UNITED STATES PATENT AND TRADEMARK OFFICE

Office Action Summary	Application No. 10/593,886	Applicant(s) ER ET AL.
	Examiner ERIN YOKAY	Art Unit 4137

DETAILED ACTION

【図23】

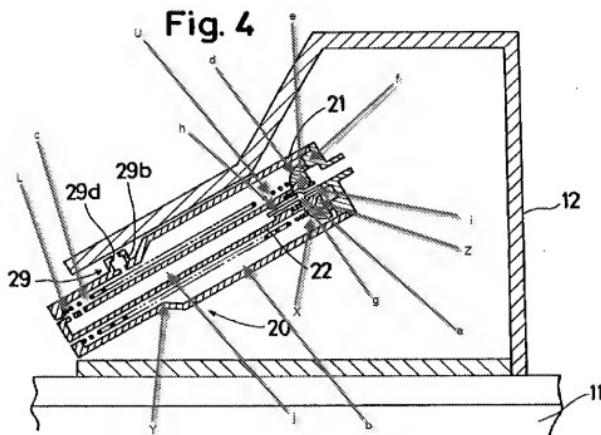
Futamura teaches:

a hollow cylindrical lower body 51,
a hollow cylindrical upper body A connected to said lower body 51,
a rectal cleaning pipe 53 moving forward with the help of water pressure for the washing operation,

- a plurality of lower body connection lugs B, on its one end, for the connection to the said upper body A,
- a lower body protrusion a C, which is close to its other end, formed by a diameter reduction,
- a lower body protrusion b D, which is closer to its other end, formed by a second diameter reduction,
- a lower body stopper E, which is at its other end, formed by an additional diameter reduction,
- a lower body pipe exit F, which is at its other end,
- a lower body o-ring operation surface G located between the lower body protrusion b D and lower body stopper E,
- a lower body water access H linked to lower body o-ring operation surface G,
- a rear passage J at the side of upper body A location,
- a mounting protrusion K, located outside of the lower body 51, facilitating the installation of the rectal cleaning apparatus.

Futamura fails to disclose:

a spring pushing the rectal cleaning pipe backward after the washing operation

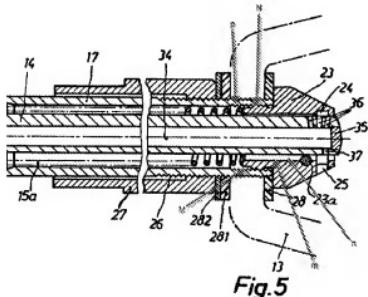
Machinaga teaches:

a spring U pushing the rectal cleaning pipe 22 backward after the washing operation

a seal ring a,

a movable stopper e,

- a lower body protrusion b L, where one end of the spring U leans ,
 - a front passage W where the spring U is located,

It would be obvious to one having ordinary skill in the art at the time of the invention to have made the incorporated the spring, seal ring, and stopper of the Machinaga bidet in the bidet system of Futamura because the spring allows for the nozzle of Futamura to retreat into the nozzle enclosure, the seal ring keeps the water from leaking between compartments, and the stopper keeps water from leaking from the nozzle.

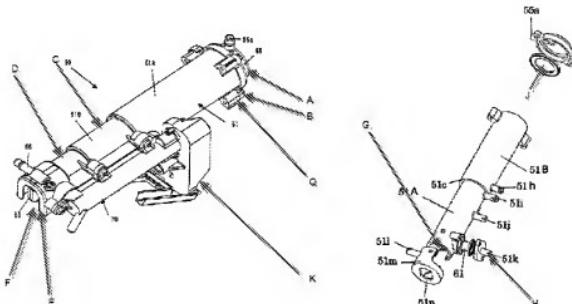
Maurer Teaches:

an o-ring M.

a gasket 23a.

It would be obvious to one having ordinary skill in the art at the time of the invention to have made the incorporated the o-ring and gasket of the Maurer bidet in the bidet

system of Futamura because the o-ring and gasket work together to keep the water from leaking out of the opening of the nozzle enclosure.

【图23】

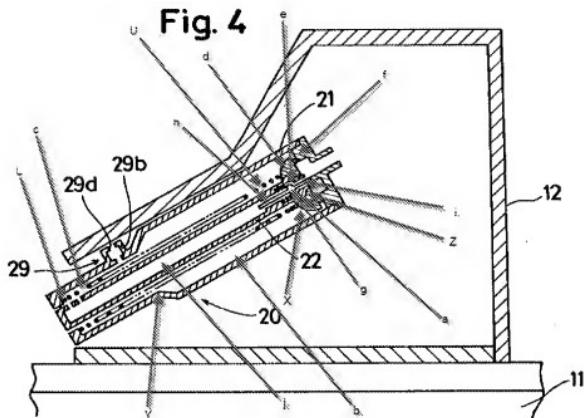
Modified Futamura teaches:

- a water exit drain K passing throughout the said pipe 53,
- plurality of the rectal cleaning exit nozzle 53h, linked to the water exit drain K, which is located at the tip of the rectal cleaning pipe 53,

- a water access hole O which links the water flow coming from the lower body water access H to the water exit drain K

Fig. 5

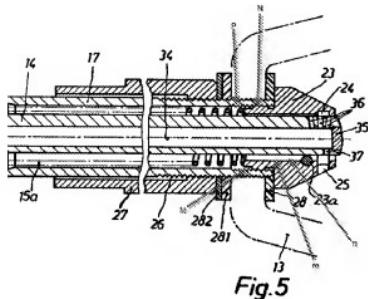
(Machinaga; Figure 4)

- a spring leaning surface X, in the form of a protrusion located in the middle of the said pipe, where one end of the spring U leans,
- a seal ring placing surface Y and a seal ring placing surface b Z together which are holding the seal ring a preventing the water leakage from rear passage b to front passage c,
- a pipe rear stopper d being integrated with the seal ring placing surface b Z; both housing and protecting the movable stopper e and at the same time providing the rectal cleaning pipe 22 stay leaned against the upper body f when the rectal cleaning pipe 22 gets to the closed position by pushed backward by the spring U,

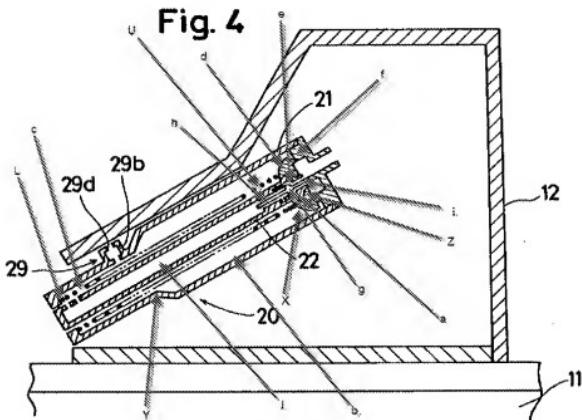
Regarding Claim 11

Modified Futamura teaches:

- a water exit drain K passing throughout the said pipe 53,

- plurality of the bidet exit nozzle 53h, linked to the water exit drain K, which is located at the tip of the bidet pipe 53,
- a water access hole O which links the water flow coming from the lower body water access H to the water exit drain K

Fig.5

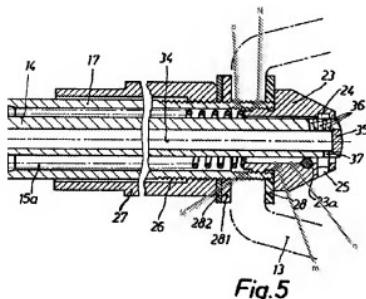
(Machinaga; Figure 4)

- a bidet spring leaning surface Y, which is the surface of the seal ring placing surface a Y looking to the front passage c, where one end of the bidet spring U leans,
- a seal ring placing surface a Y and seal ring placing surface b Z together which are holding the seal ring a preventing the water leakage from rear passage b to front passage c,
- a pipe rear stopper d being integrated with the seal ring placing surface b Z; both housing and protecting the movable stopper e and at the same time providing the

bidet pipe 22 stay leaned against the upper body f when the bidet pipe 22 gets to the closed position by pushed backward by the spring U,
